TECHNICAL SERVICE BULLETIN

Manual Sliding Door(s) - Various Manual Sliding Door Related Symptoms

21-2102

| Ford 2015-2021 Transit |

Figure 1

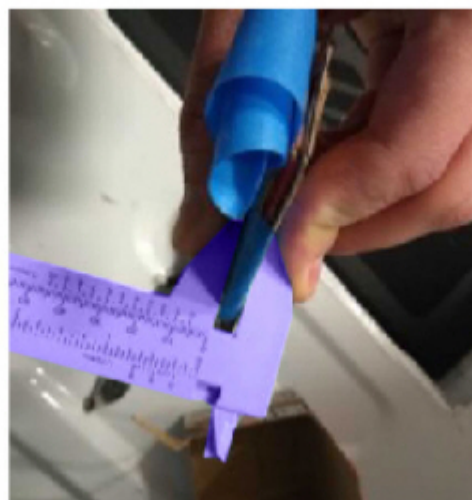
- (2). No - proceed to Step 6.
6. Remove the ajar switch mating connector. Tap the switch connector (Figure 1, Callout 2) lightly using a soft tool to move the switch housing outboard by about 3 to 4 grooves (Figure 1, Callout 1).

7. Reattach the mating connector.
8. For first time repair attempts, prepare a 5 +/- 0.25 mm spacer by stacking an appropriate number of hard cardboard strips (Example: oil filter box) and bind them together with painter's tape. (Figure 1) Proceed to Step 11.
